# AUDIO SERVICE

BULLETIN NO.: 07-81

SUBJECT: CR-2020

### ELECTROLYTIC CAP. C. BOARD

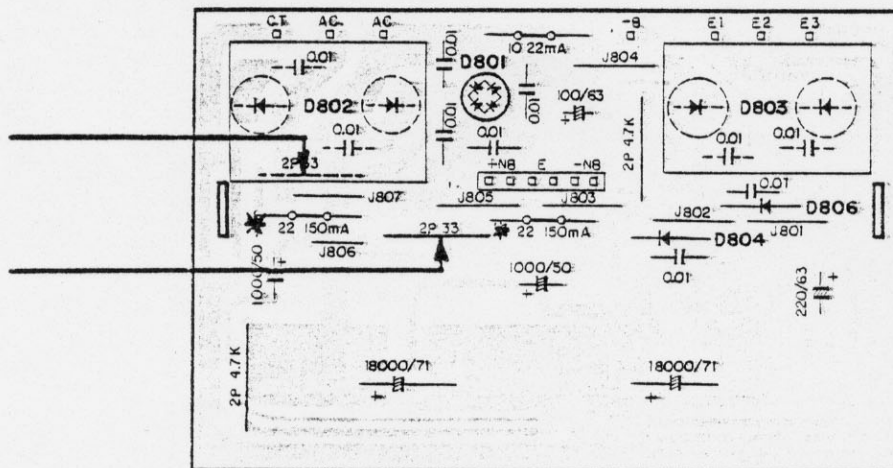
Problem: Intermittent power supply.  
Receiver goes on and off, speaker relay clicking.

Cause: R 801 and R 802 (33 ohm) in electrolytic capacitor circuit board get hot and unsolder themselves.

Location of resistors:

Remedy: Remove both resistors and install new 33 ohm, 3/4 watt wire wound resistors.

Mount the resistors approximately 1/4 inch away from the circuit board.

We suggest to use Ohmite #4374. These resistors are available from Yamaha Canada Music, Parts Department.

\* Also replace the 22 ohm 150 mA fuse resistors with Ohmite #4369 22 ohm 3/4 watt resistors.
